CRWF Proposed Modification 2 SSD 6679

April 2020

Figure 2 Existing Approved tracks 9 and 11

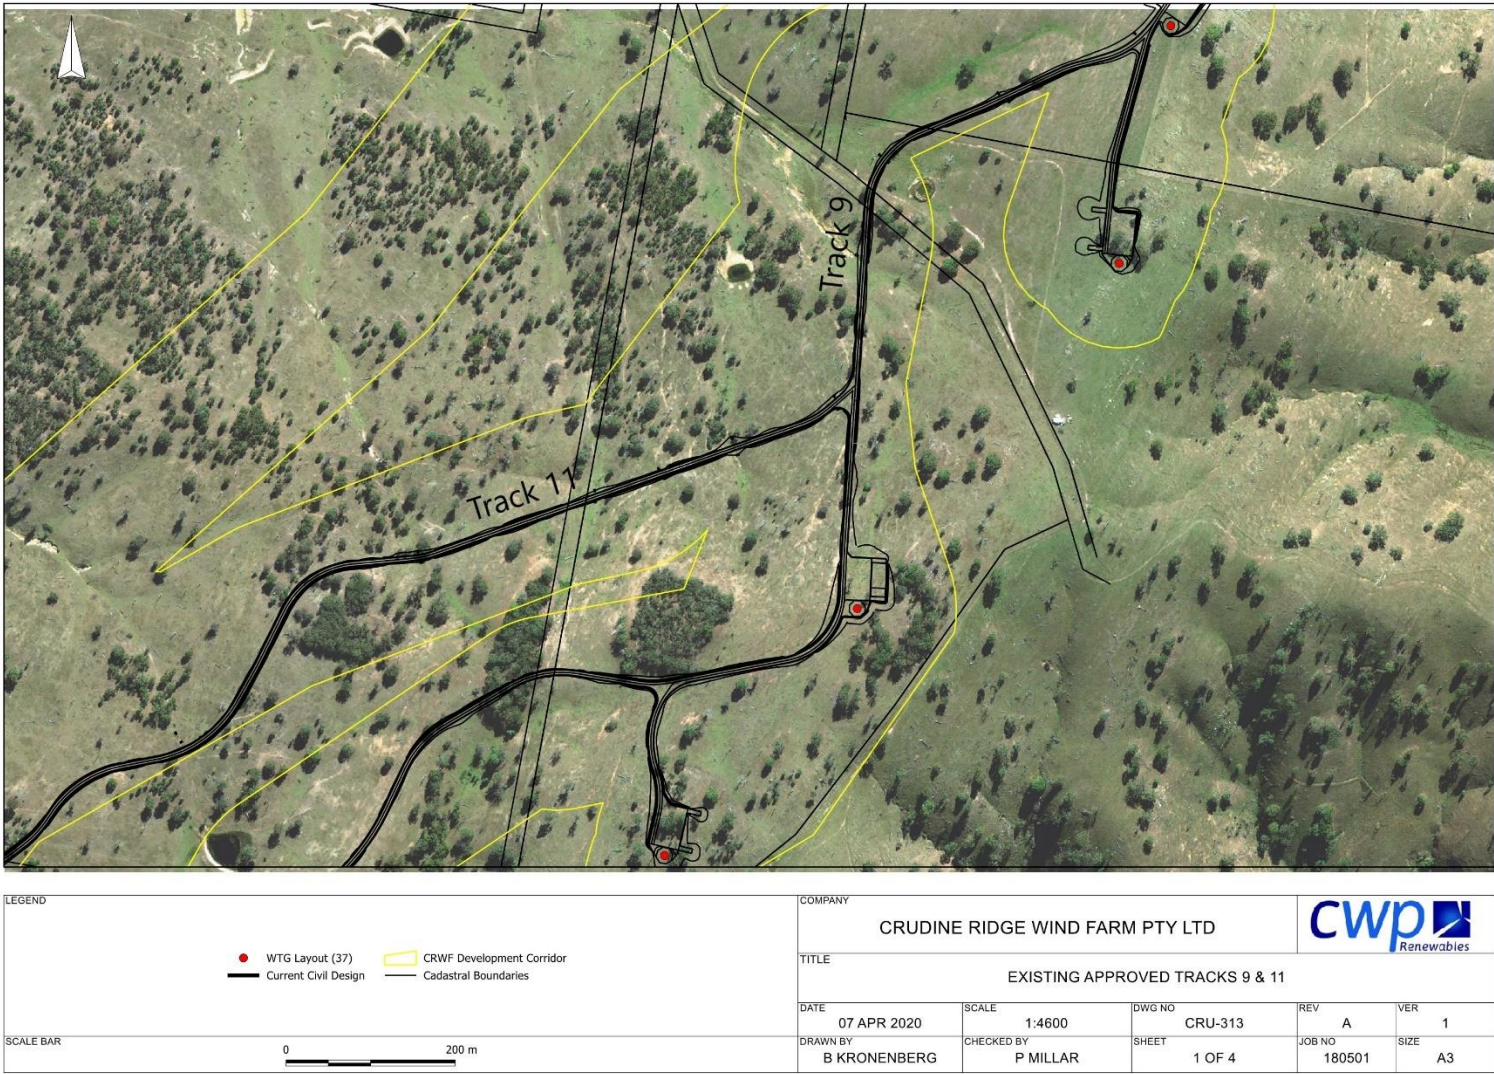
The purpose of the Modification is to remove 1590 metres of track from the development and replace it with 730m of track. The Modification would see 1410 metres of Track 11 not constructed and 180 metres of track 10 not constructed. This would be replaced with 470 metres of track linking WTG A35 with WTG A38. This includes 260 metres of new Construction Corridor to a width of 30 metres. The second section of track to be constructed is 280 metres from Chainage 1400 on Track 9 to Chainage 800 on Track 11. This includes 60 metres of new Construction Corridor to width of 30 metres.

Figure 3 Proposed tracks to be removed

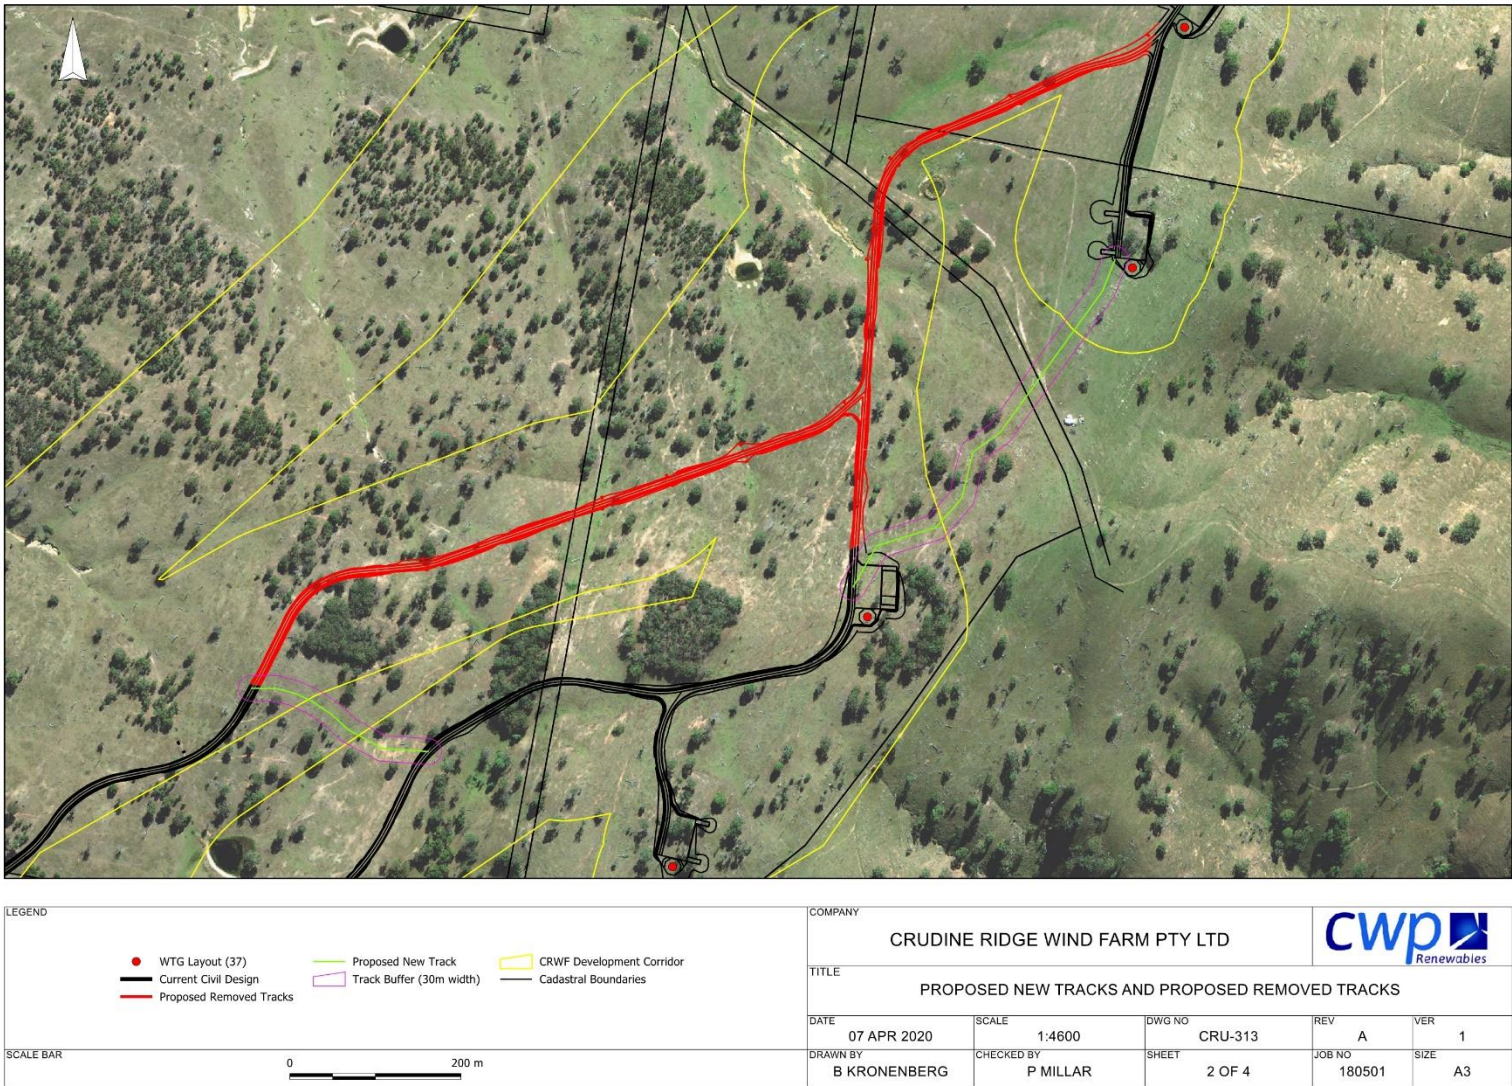
Figure 3 Track section to be removed
